Re: Rezoning of 575 Zor Shrine Place – West Parcel

Please accept this Letter of Intent, Application, and plans as our formal request for final approval to rezone the west parcel of the site at 575 Zor Shrine Place from the Suburban Employment (SE) to the Traditional Residential – Urban District (TR-U2). The project team came before the Commission on July 13th with an informational plan, and again on August 17th for initial approval. The project received initial approval at the 8/17/22 meeting with the following summarized comments:

ZOR SHRINE WEST

BACK TO THE DRAWING BOARD

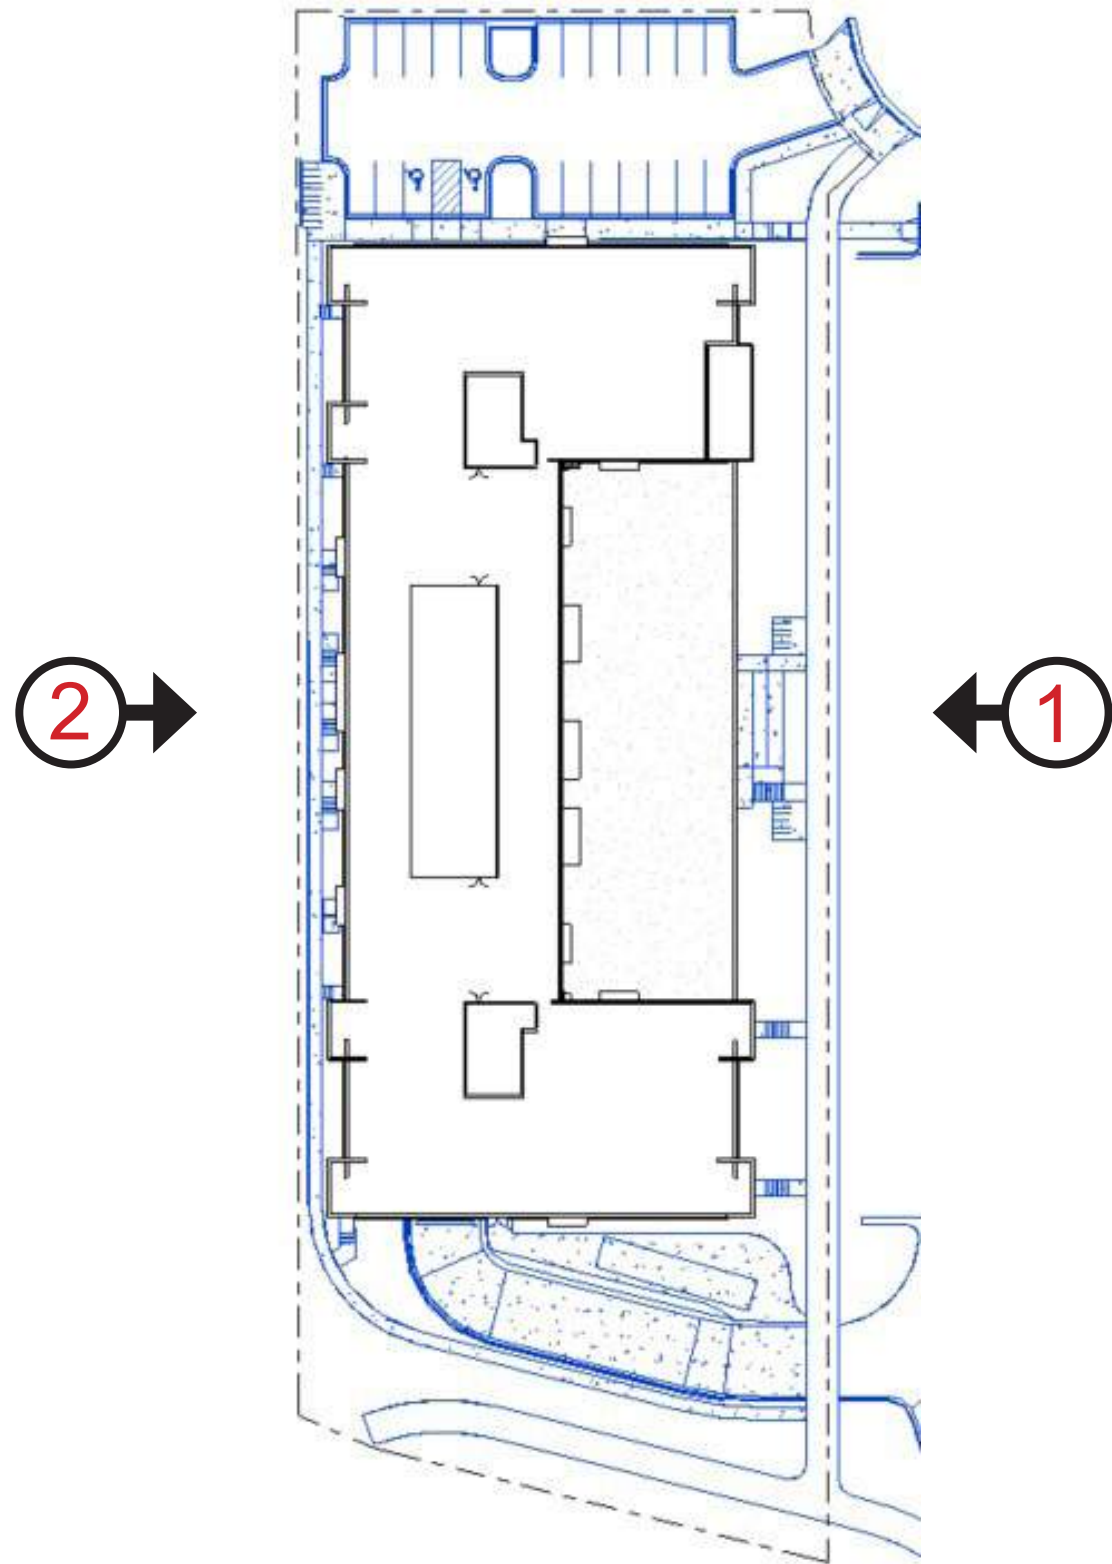
PREVIOUS DESIGN - SUBMITTED 08.17.2022

UPDATED DESIGN - SUBMITTED 09.21.2022

- DESIGN UPDATED PER UDC FEEDBACK:
- REMOVED SCREENED PORCHES
 - MATERIAL TRANSITIONS UPDATED
 - LONG EXPANSES OF LAP SIDING ADDRESSED
 - POSITIVE TERMINATION AT ROOFTOP
 - TREE SPECIES AND LANDSCAPE PLAN UPDATED

ROOFTOP TERMINATION

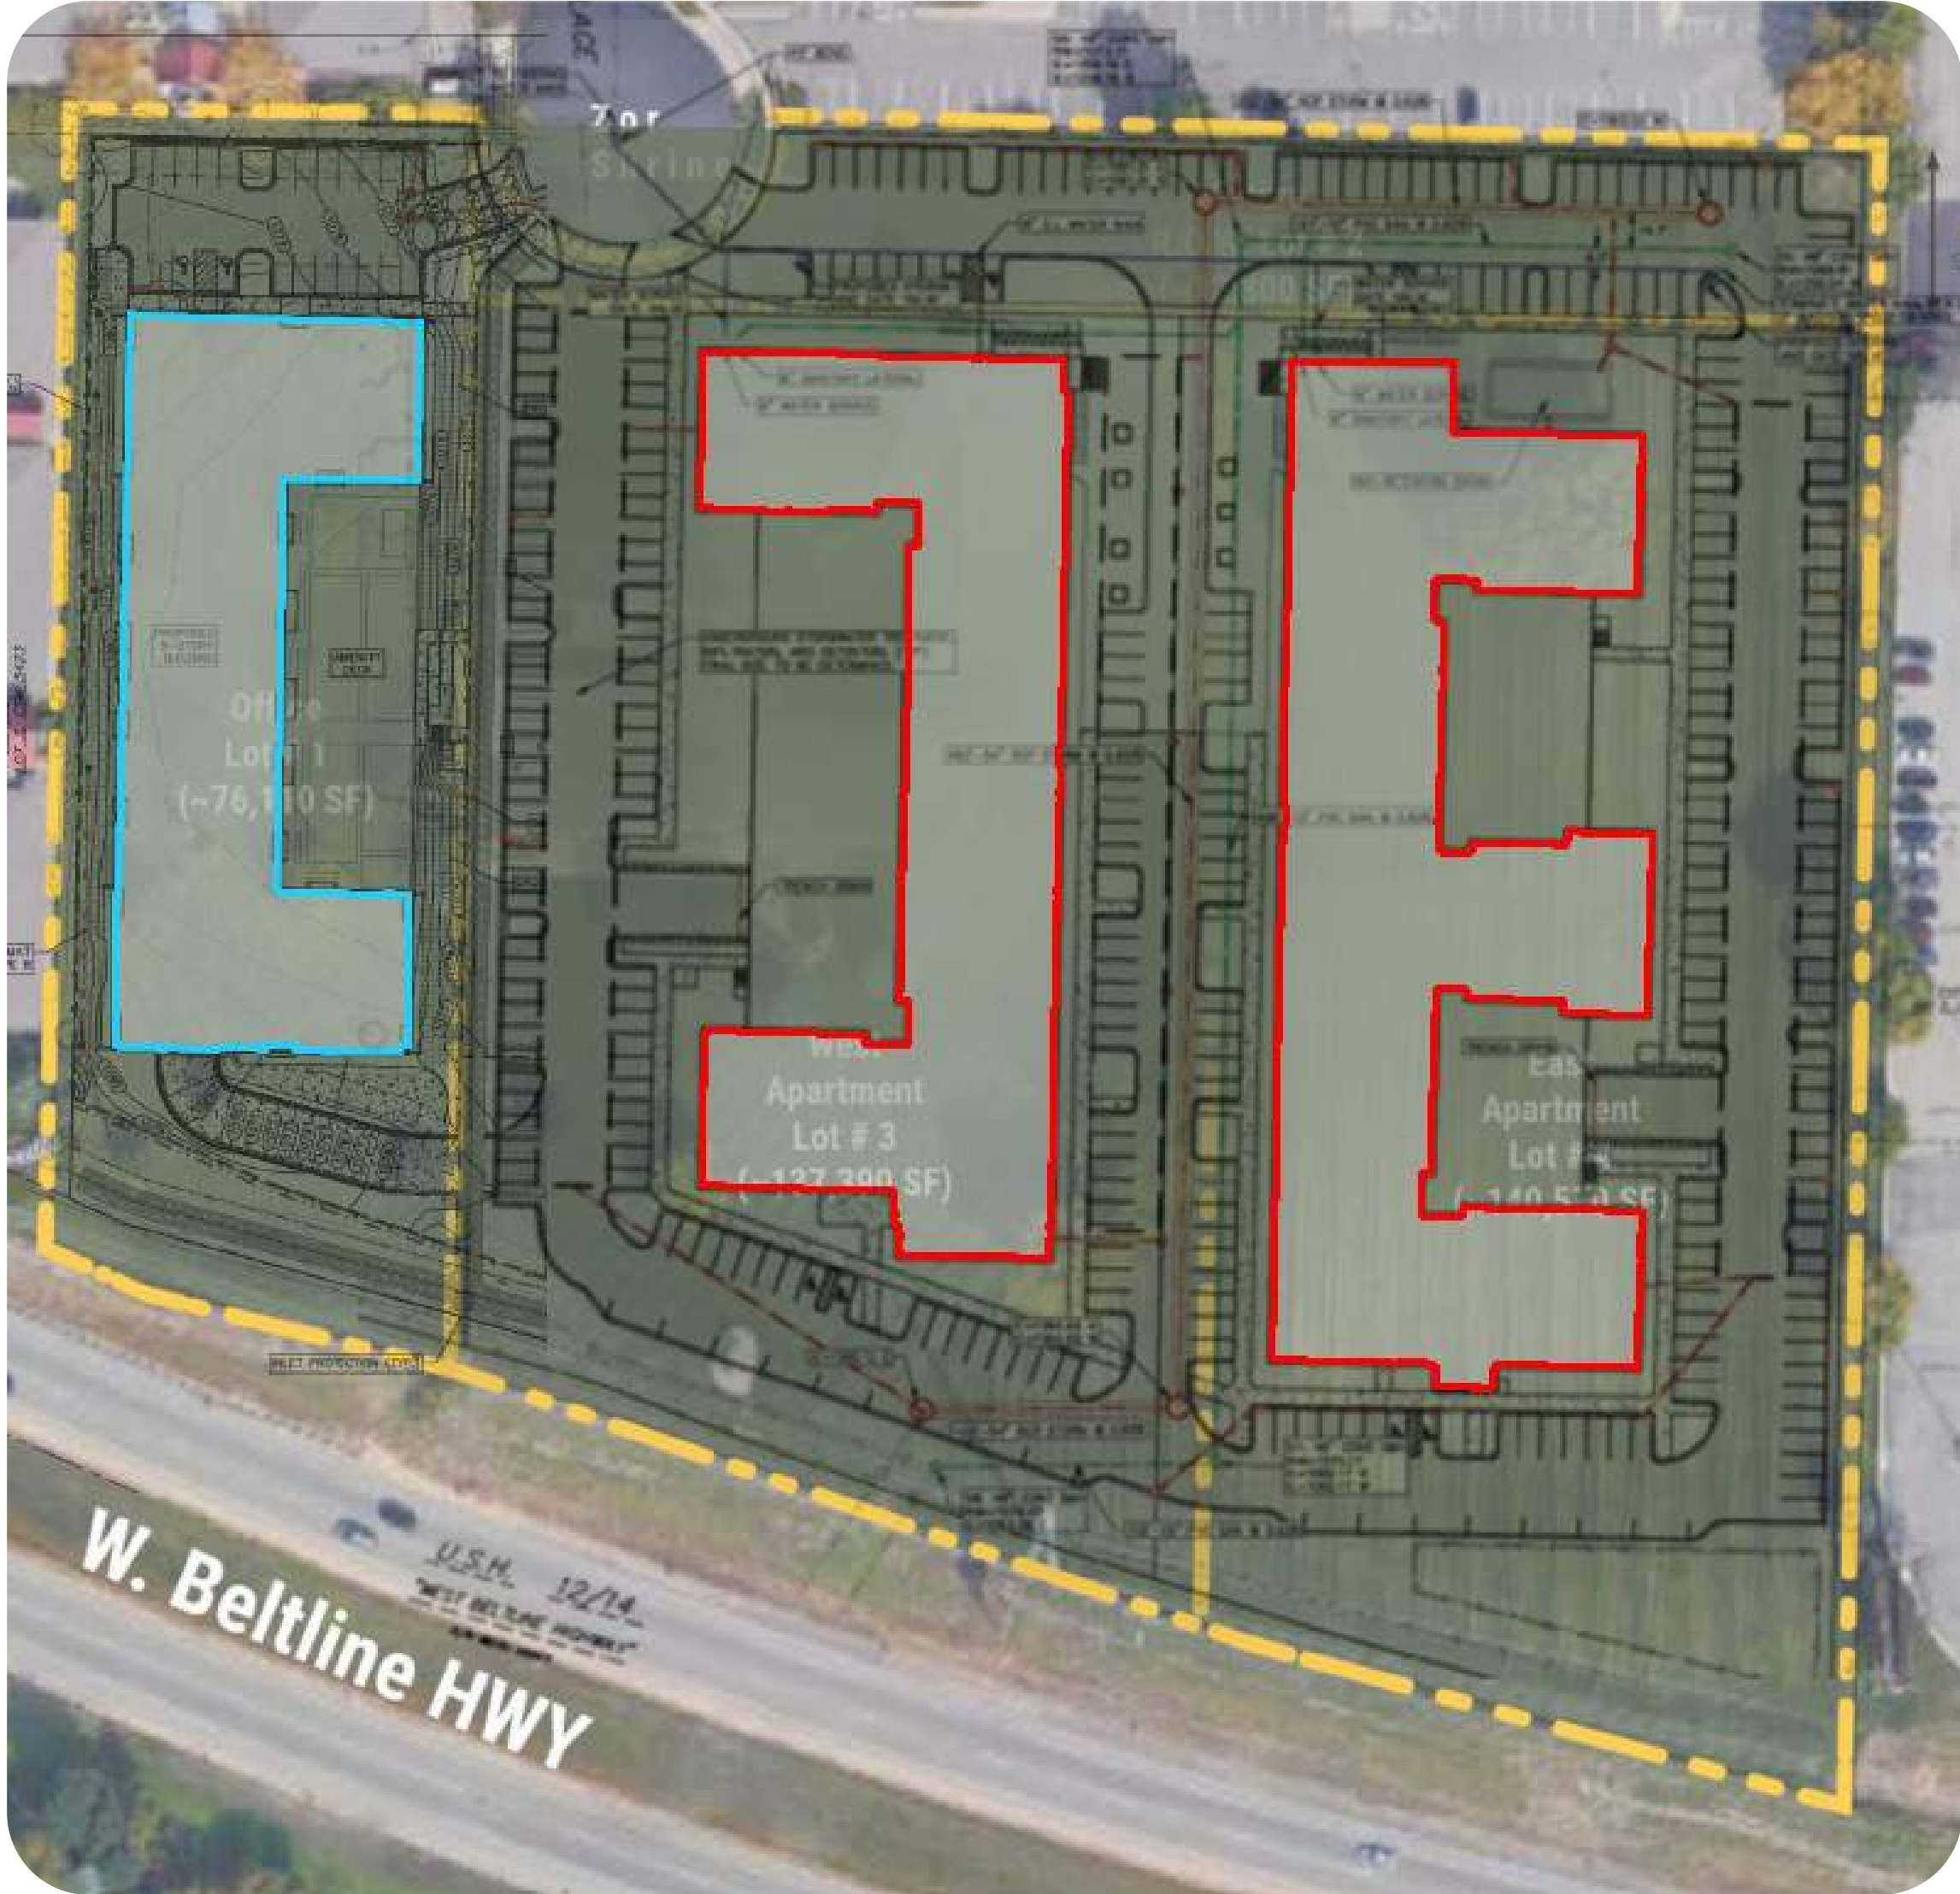
BOARD AND BATTEN SIDING AND PREFINISHED CHARCOAL PARAPET ADDED AT 5TH LEVEL TO CREATE POSITIVE TERMINATION FOR BUILDING ELEVATIONS.

- Board and batten siding and a prefinished charcoal parapet have been added at the 5th level to create a positive termination for building elevations.
